# Access Compliance Report

## Public Rights-of-Way

Intersection ID: N/A	Main Street: PRINCETON_AV	Cross Street: SOMERSET_DR	Location: NE
ADA ID: 657F5ADE104E	Ramp Type: Directional2	Initial Pass/Fail: Fail	Overall Compliance: No
		Severity Score: 8.75

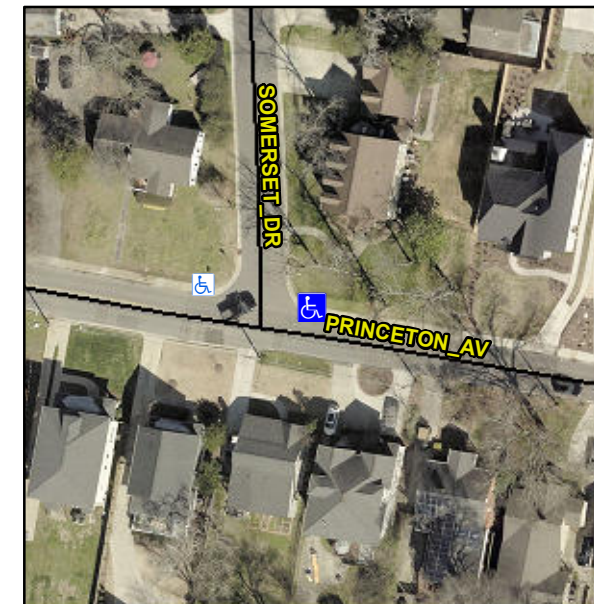
**R304.5.1**

Compliance	Description	Data	Compliance	Description	Data
N/A	Ramp Length (in)	81.0	N/A	Grade Break?	N/A
No	Ramp Width (in)	47.0	N/A	Grade Break Slope (%)	0.0
Yes	Ramp Slope (%)	0.9	N/A	Grade Break XSlope (%)	0.0
Yes	Ramp XSlope (%)	0.8			
N/A	Flare Type LT	N/A	N/A	Flare Type RT	N/A
N/A	Flare Slope LT (%)	N/A	N/A	Flare Slope RT (%)	0.0
N/A	Flare Traversable LT?	N/A	N/A	Flare Traversable RT?	N/A
N/A	Landing Length (in)	0.0	N/A	DWS Provided?	N/A
N/A	Landing Width (in)	0.0	N/A	DWS Contrast?	N/A
N/A	Landing Slope (%)	0.0	N/A	DWS Length (in)	N/A
N/A	Landing X Slope (%)	0.0	N/A	DWS Full Width?	N/A
N/A	Landing Curb? (Y/N)	N/A	N/A	DWS Offset LT (in)	N/A
N/A	Shared Landing?	N/A	N/A	DWS Offset RT (in)	N/A
N/A	Gutter Ponding?	0.0	N/A	Gutter Slope (%)	N/A
N/A	Gutter Lip Ht (in)	0.0	N/A	Gutter X Slope (%)	N/A
N/A	Painted X Walk1?	No		Road Slope (%)	6.6
	X Walk 1 Direction	To W		Road X Slope (%)	2.0
	X Walk 1 Width (in)	N/A		Clear Space?	N/A

**Remove & Replace Entire Ramp.**
